JRC comments and questions on the CN draft of the
regulatory text for the GTR EVS vibration test

September 29, 2021

Figure 1 Random vibration test curve for battery packs or systems on vehicles of Classes M1 and N1

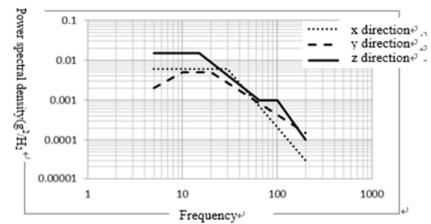
JRC Opinion (in agreement with CN 6.2.2.3.2) → If a random vibration test profile would be considered as an alternative to the current GTR No.20 sine wave test profile, **JRC could agree on the lower and upper frequency values, i.e., 5 Hz and 200 Hz, respectively, as proposed in both China's and OICA's proposals**

Figure 2 Random vibration test curve for battery packs or systems on vehicles other than Classes M1 and N1

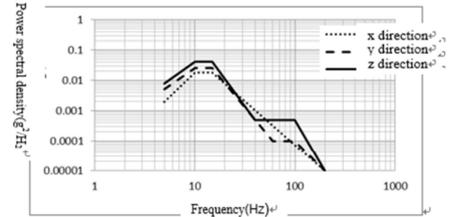
JRC comment/question: Would it not be possible to be more specific defining vehicles “other than M1, N1”?

Suggestion: to specify clearly the “other than M1, N1 vehicles” term. (For less demanding applications what should happen?)

JRC Opinion → Based on the data shared by China on the vibration test parameters and profiles, JRC would be in favor of requiring different vibration test parameters for category M1, N1 vehicles as compared to vehicles of other categories. Nevertheless, JRC would welcome more data, also from other stakeholders, to demonstrate the need for such differentiation and to define the vibration test parameters for vehicles of categories other than M1, N1.
